SUNDRY NOTICES AND REPORTS ON WELLS
Do not use this form for proposals to drill or to re-enter an abandoned well. Use Form 3160-3 (APD) for such proposals.

Wilson 1

Burlington Resources requests permission to P&A the subject well per the attached procedure, current and proposed wellbore schematics.

CONDITIONS OF APPROVAL

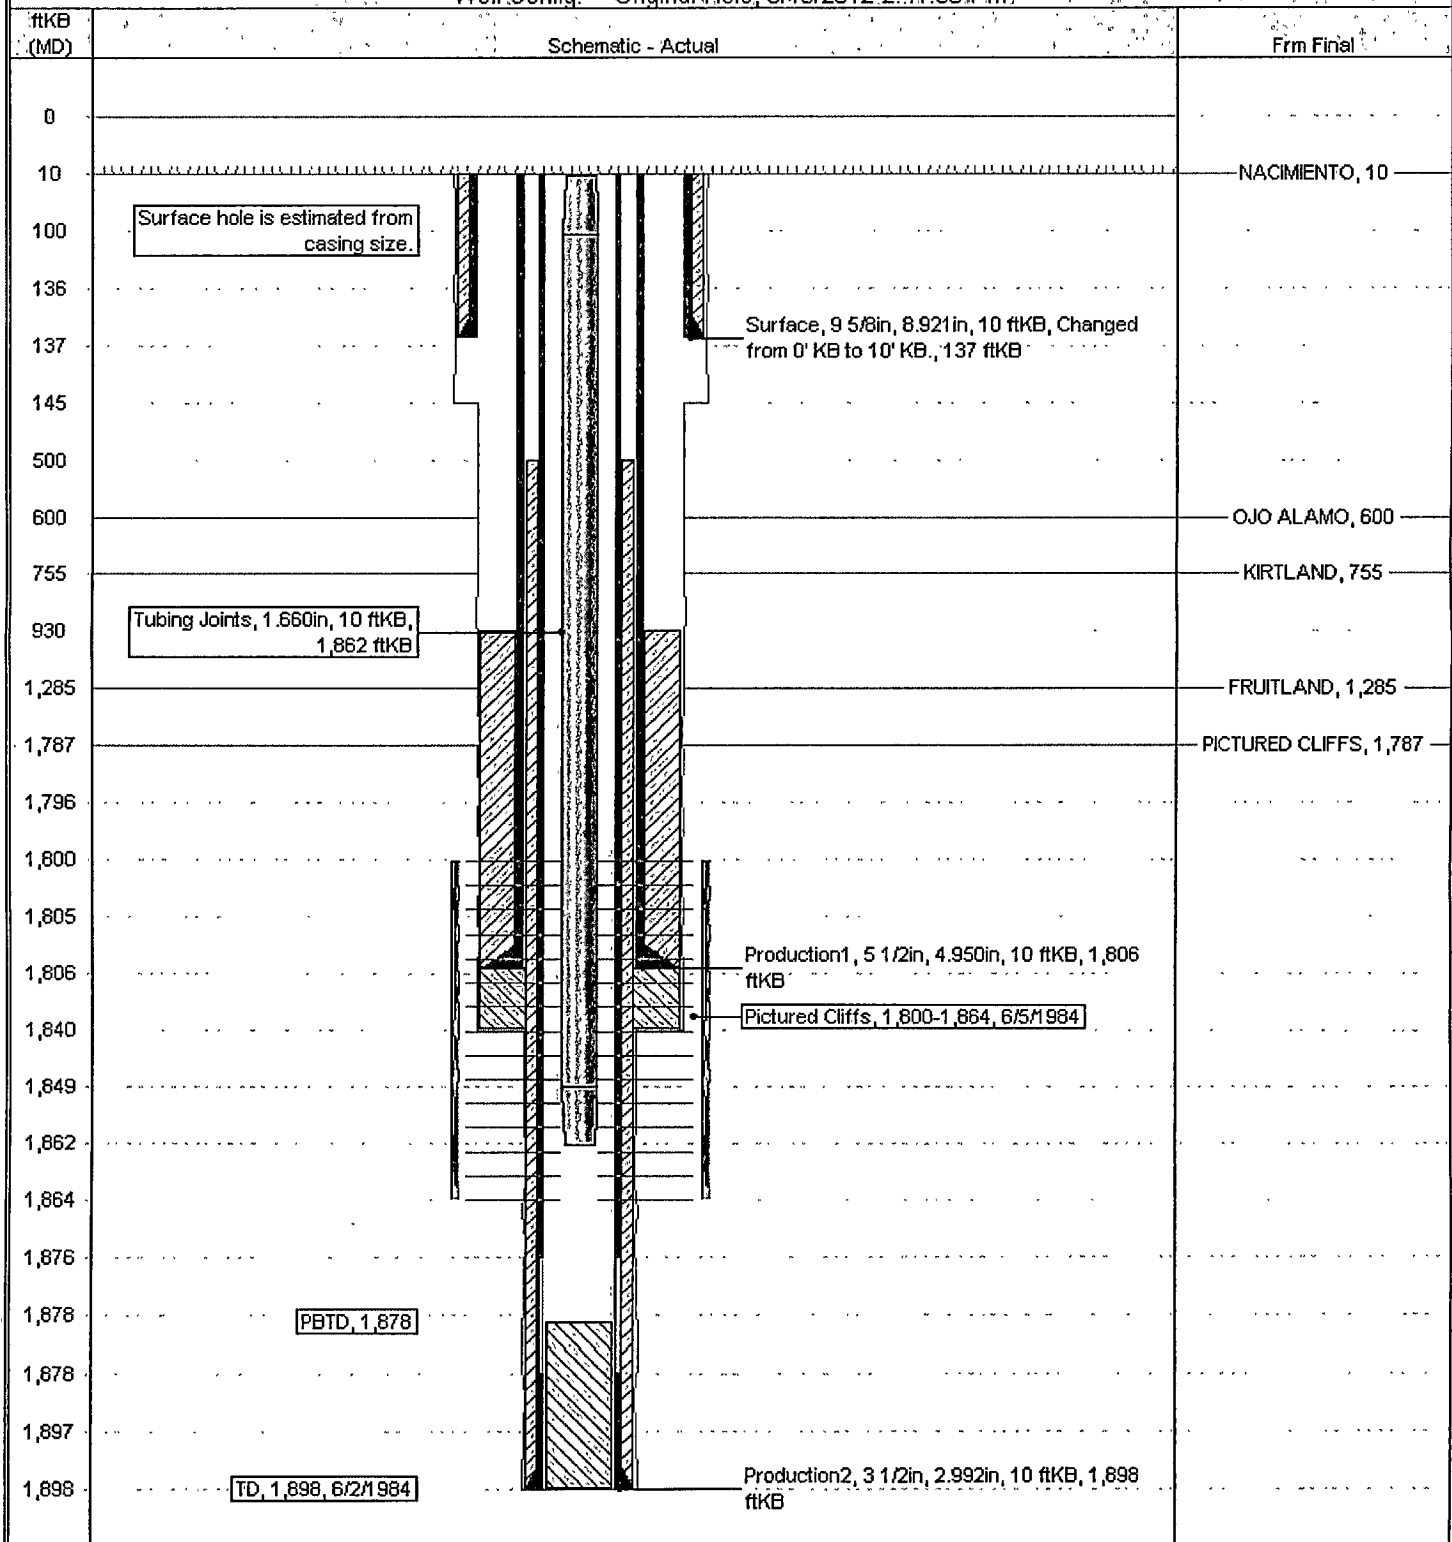
* Run CBL prior to cementing plug #1

1. Plugging operations authorized are subject to the attached "General Requirements for Permanent Abandonment of Wells on Federal and Indian Lease."
2. Farmington Office is to be notified at least 24 hours before the plugging operations commence (505) 564-7750.
3. The following modifications to your plugging program are to be made:
 - a) Place the Kirtland/Ojo Alamo plug from 805' – 550' inside the 3 ½" and outside the 5 ½" casing.
